A — INSTALL ADVANCE PED PHASE — 7/03

MARYLAND DOT - STATE HIGHWAY ADMINISTRATION
Office of Traffic & Safety
TRAFFIC ENGINEERING DESIGN DIVISION
(Traffic Signal Plan)

MD 26 at Milford Mill Road

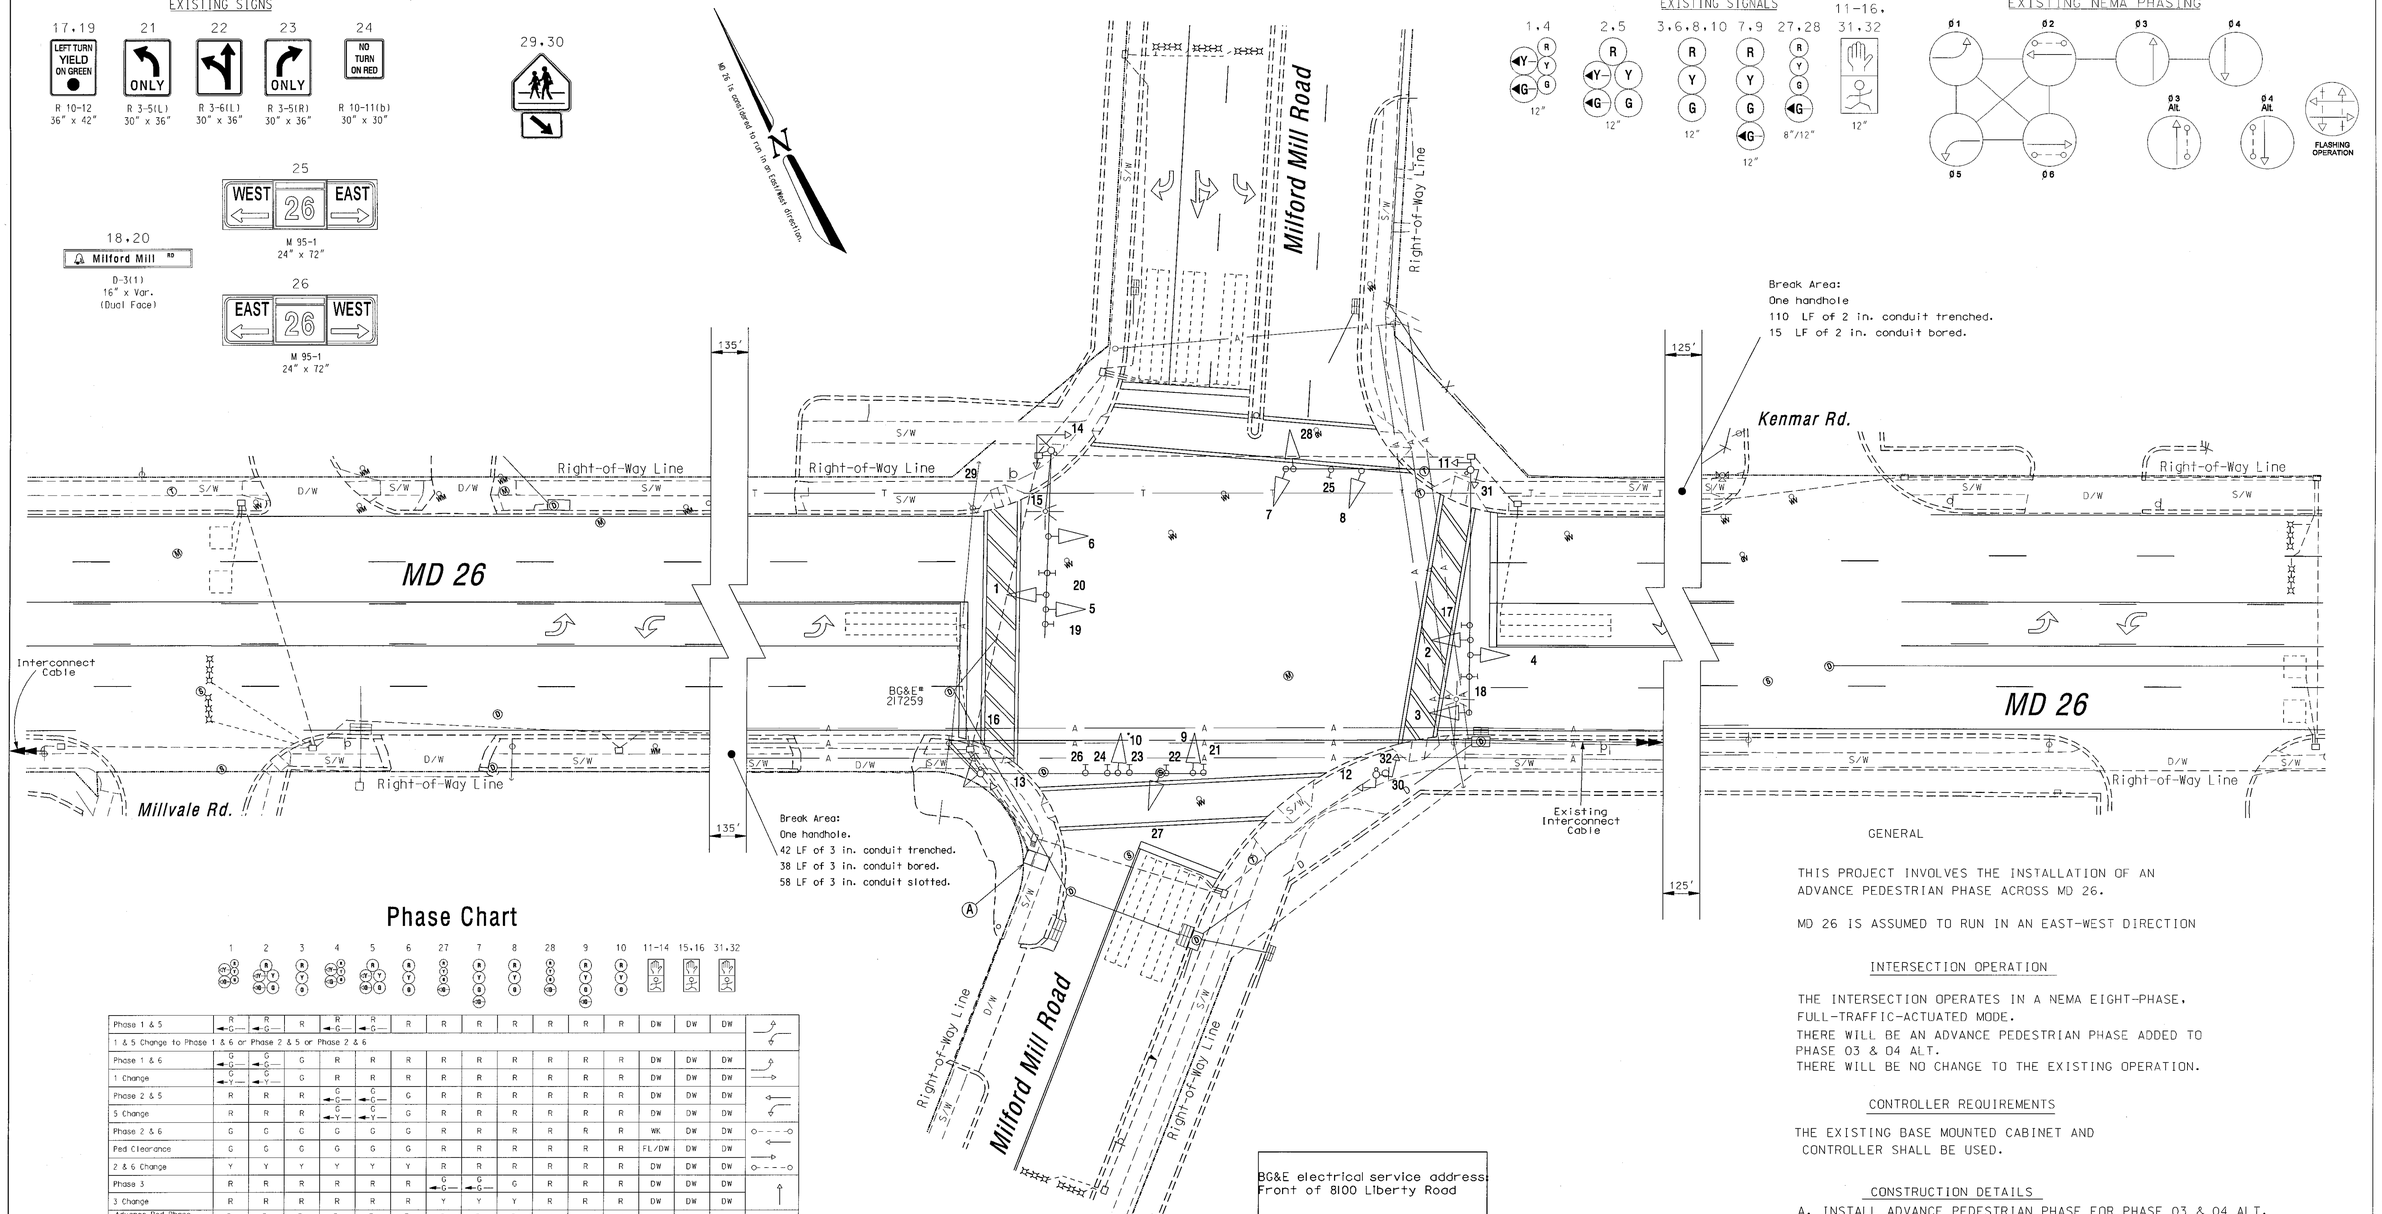
THE INTERSECTION OPERATES IN A NEMA EIGHT-PHASE, FULL-TRAFFIC-ACTUATED MODE.
THERE WILL BE AN ADVANCE PEDESTRIAN PHASE ADDED TO PHASE 03 & 04 ALT.
THERE WILL BE NO CHANGE TO THE EXISTING OPERATION.

A. INSTALL ADVANCE PEDESTRIAN PHASE FOR PHASE 03 & 04 ALT.
